## 061-18-CA

### 1012 W CABARRUS STREET

## APPLICATION FOR A CERTIFICATE OF APPROPRIATENESS – STAFF REPORT

Nature of Project: Landscape master plan; install retaining walls and steps

COA 061-18-CA staff evidence  
from approved COA 125-17-CA

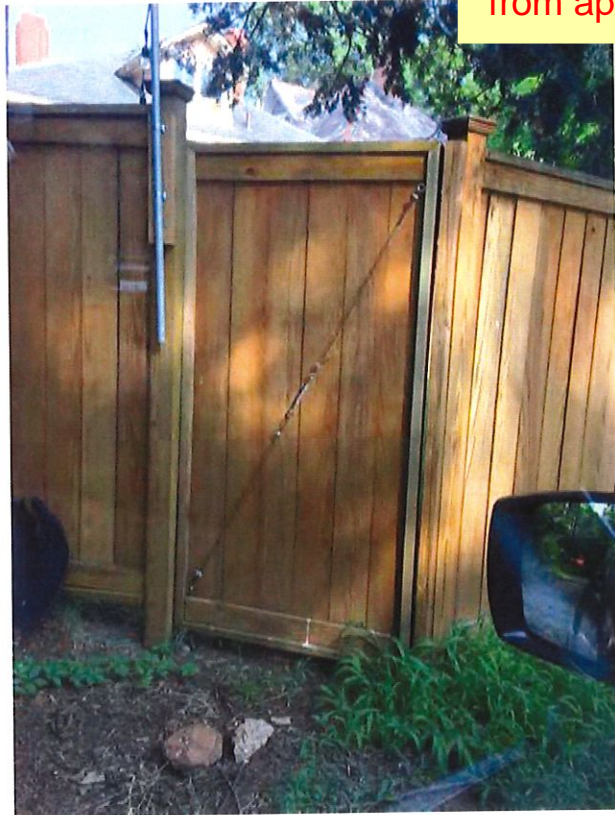
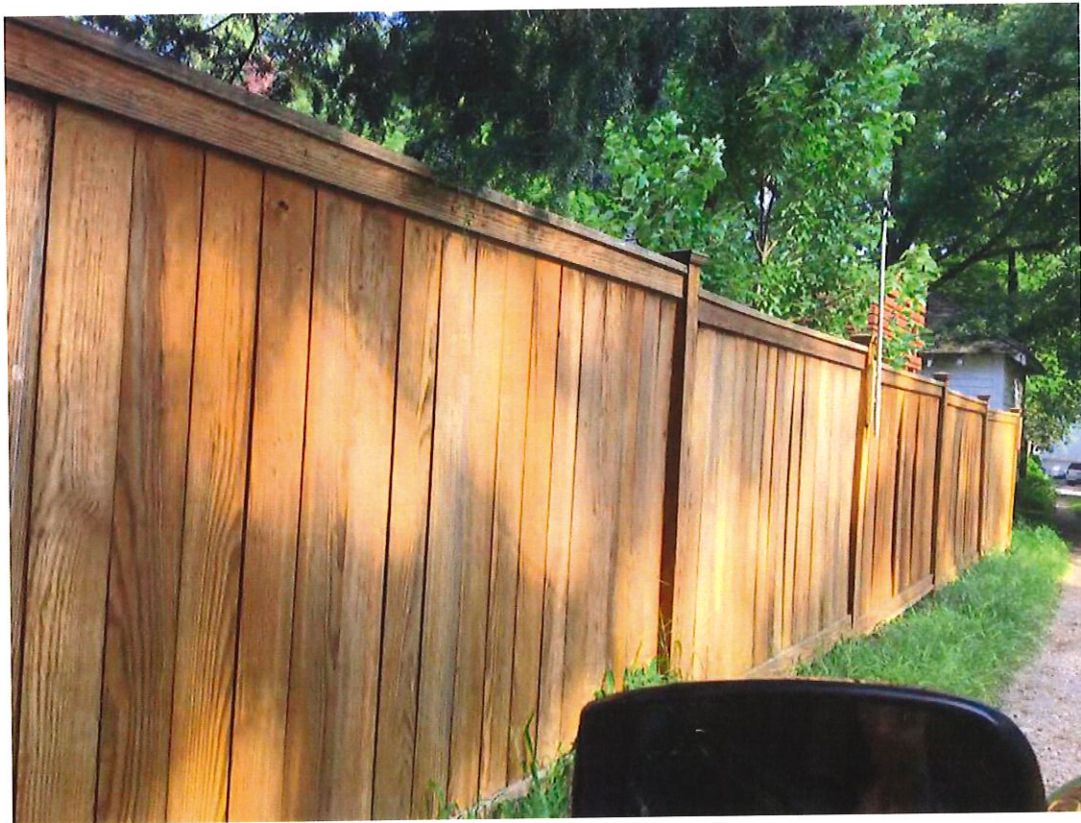
- 5\* The backyard fencing was approved under COA 125-17-CA as a 6’ high fence that began roughly at the back wall of the original house. Drawings included with the new application note an 8’ high fence that extends to the front wall of the house on the south side and to the end of the driveway on the west side. The taller fence height is atypical of the historic district.

note change in fence  
height on current  
application to 8'

Retaining wall block dimensions:

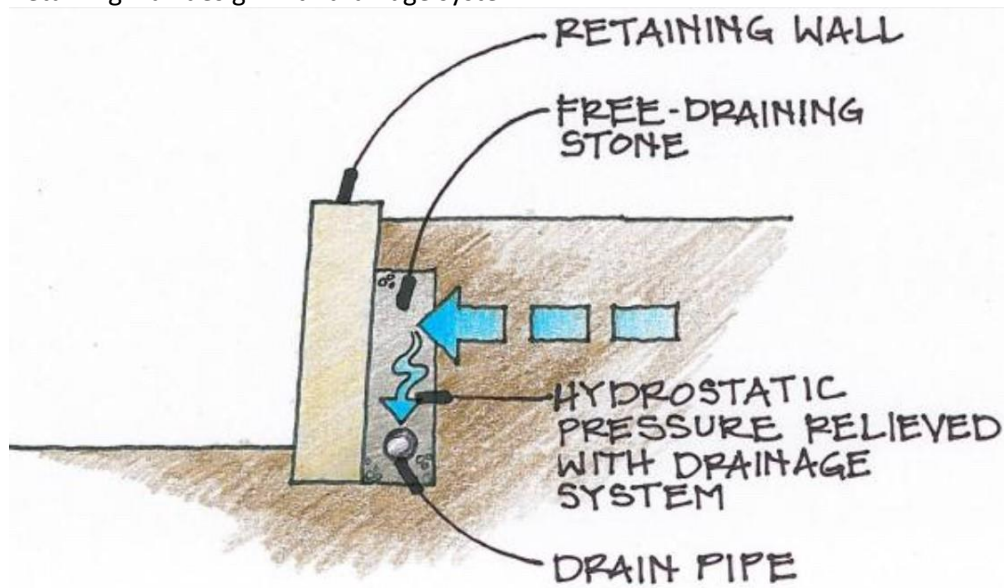
- 2\* Curved front precast concrete blocks are proposed for the retaining wall. Flat faced concrete block is a historic and common material in the historic district. The use of this block has been denied by the commission, one of such cases is at 410 S Boylan Avenue (090-16-CA)

Staff suggests that the committee defer the application due to conflicting information from the previously approved COA 125-17-CA and to allow time for the applicant to propose an alternative retaining wall material.

704 S. Florence Street

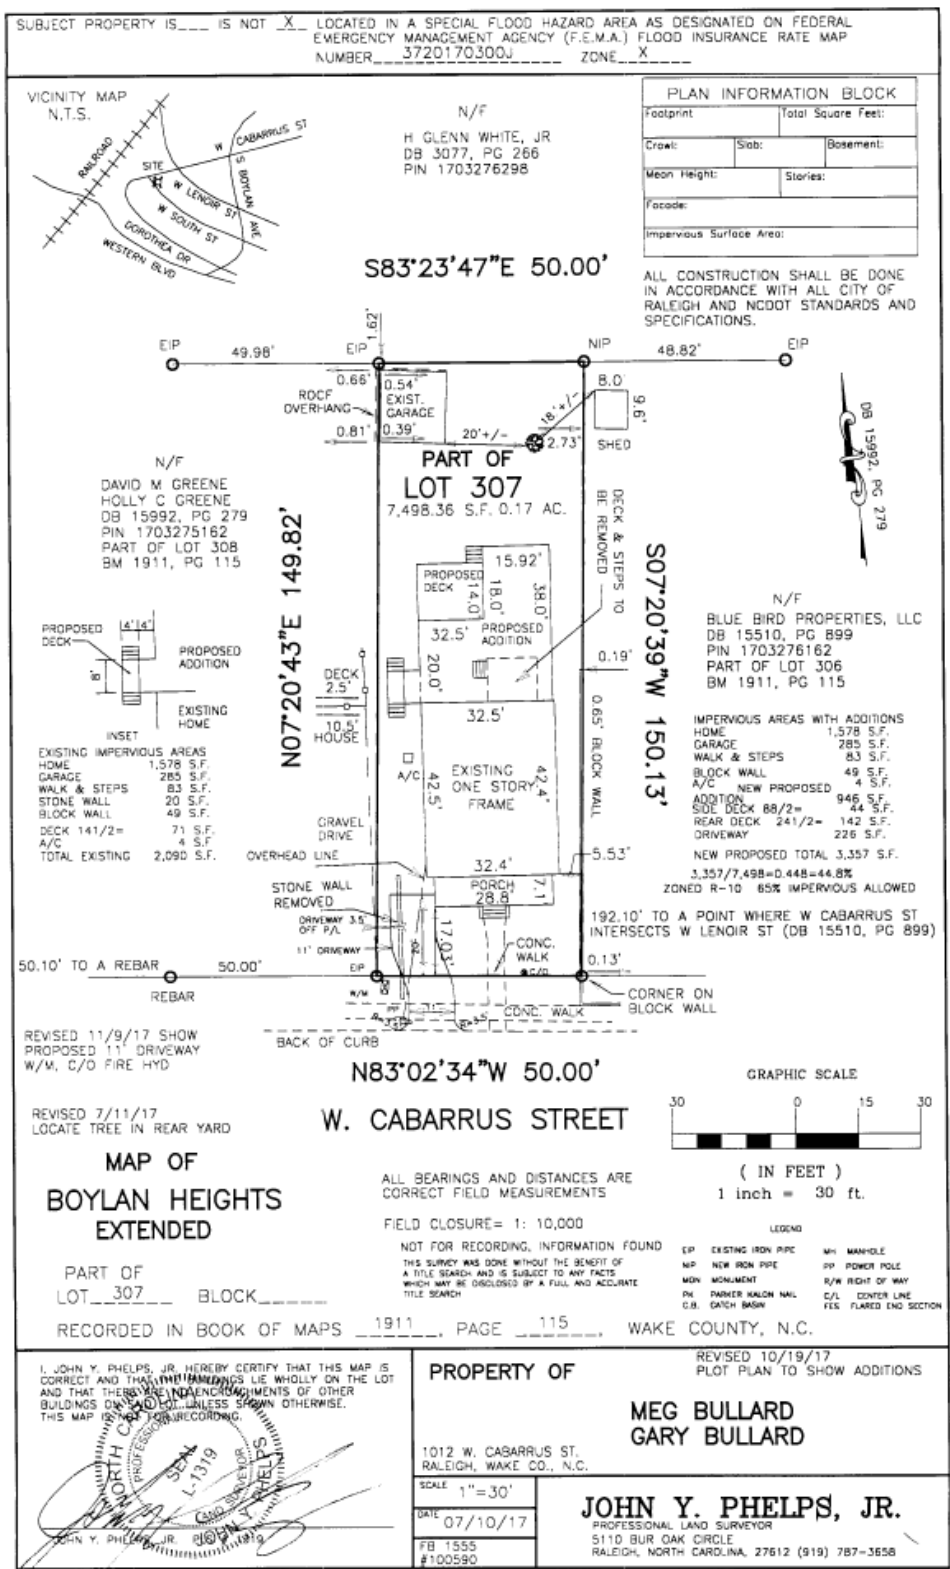
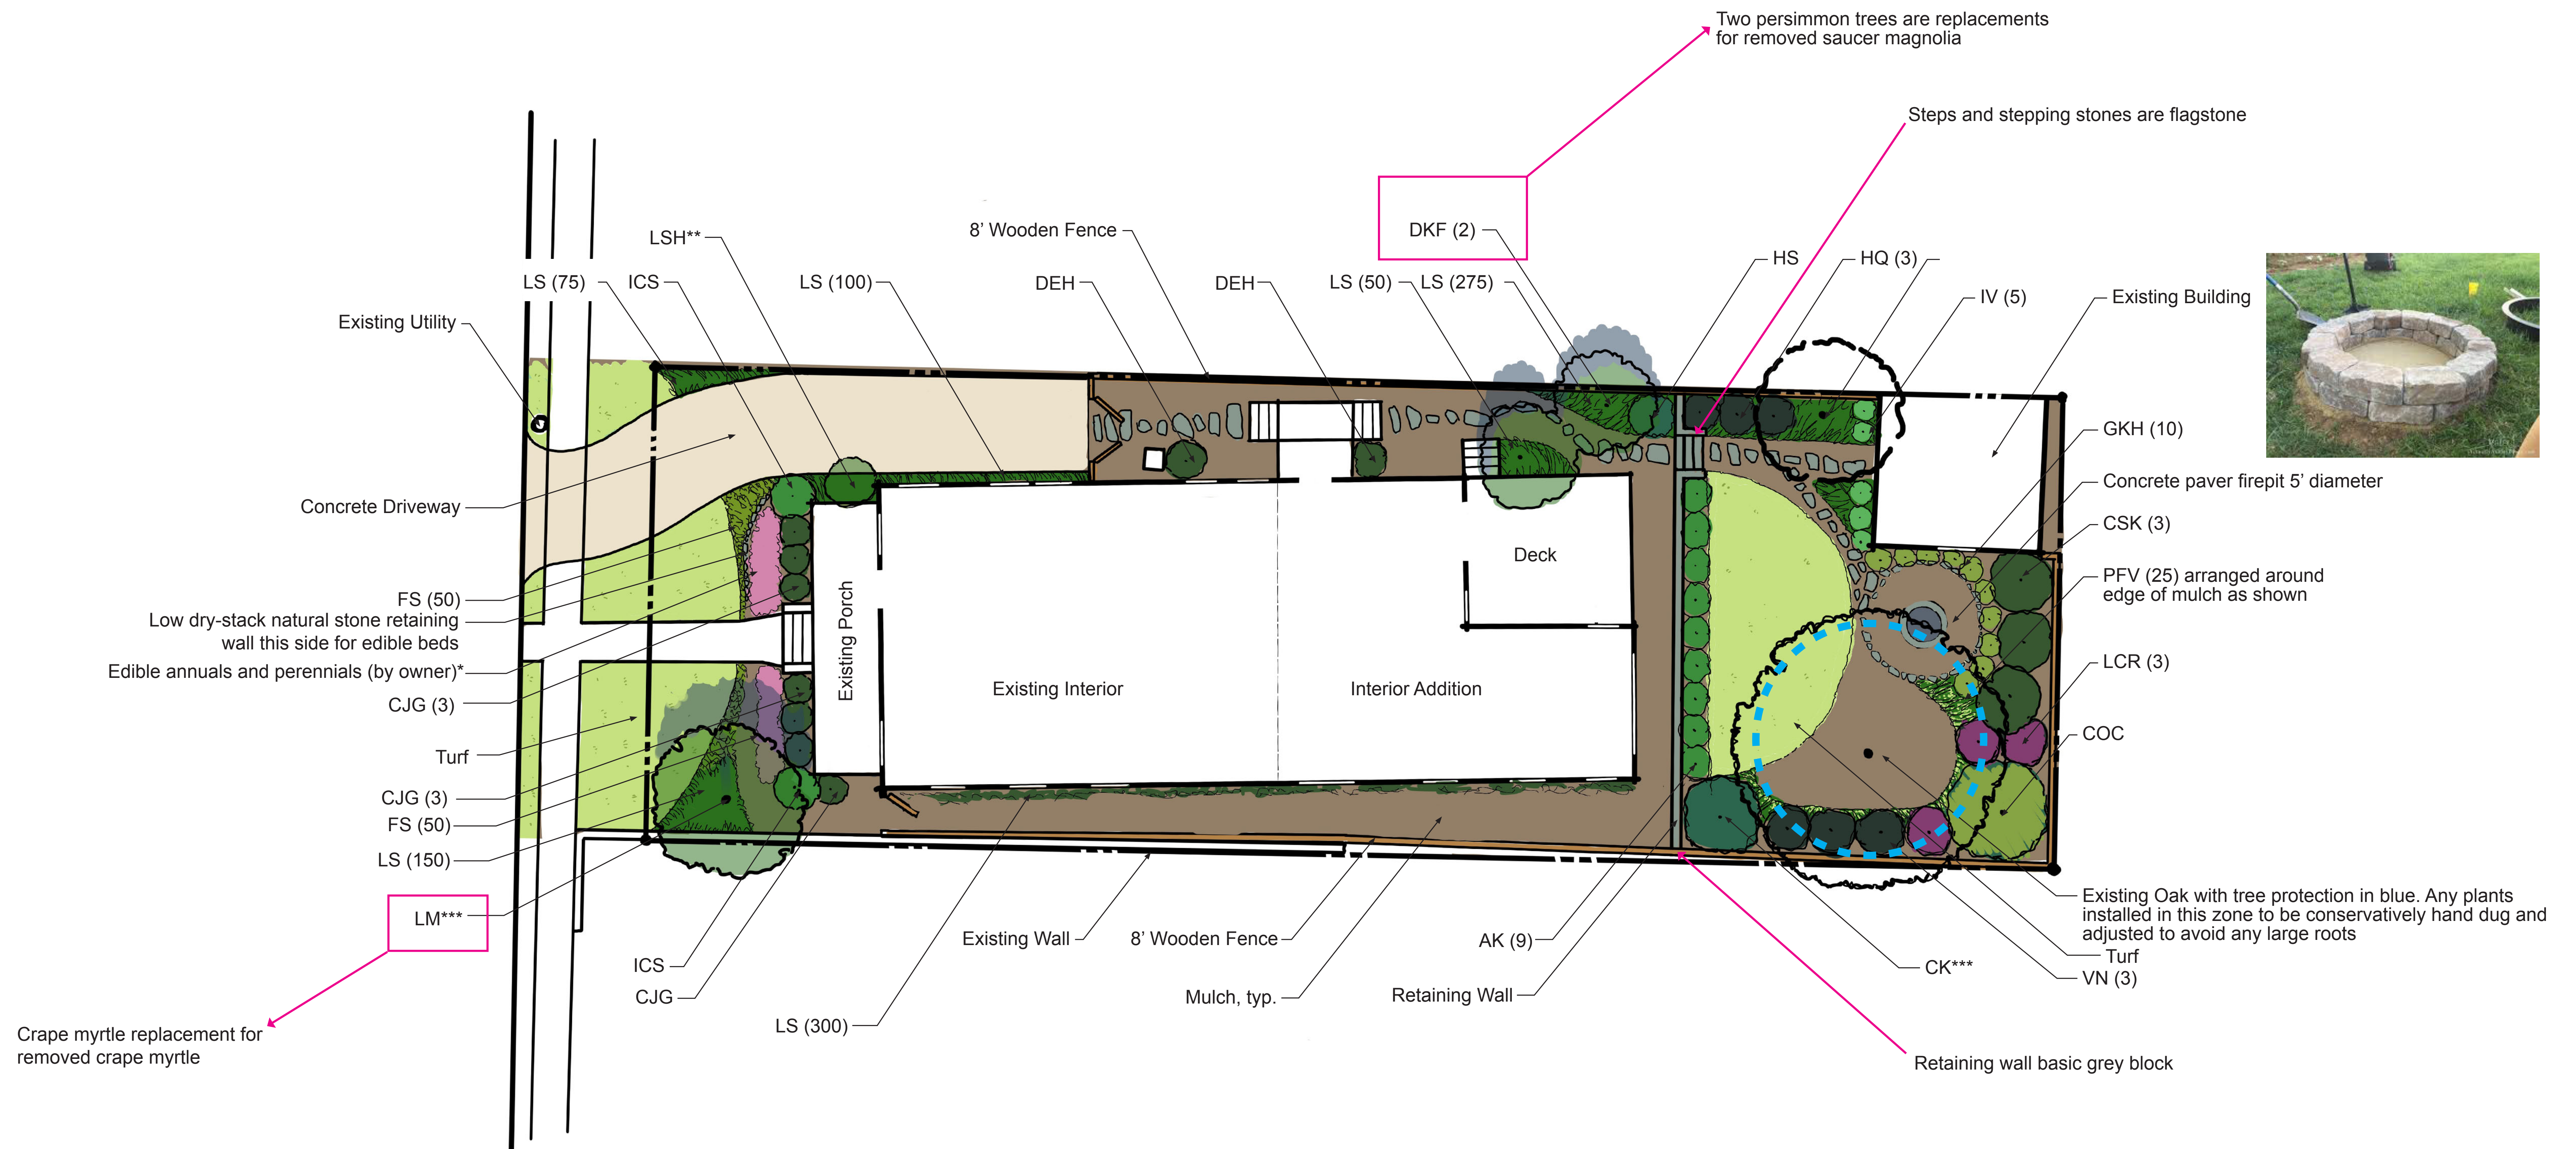
- 3\* Photos of concrete block retaining walls were provided at 704 S Florence St and 913 W South St, neither of which received COA approval.
  - 4\* A dry-stack stone retaining wall is proposed for the front garden beds. Dry-stack construction is atypical in the historic district.
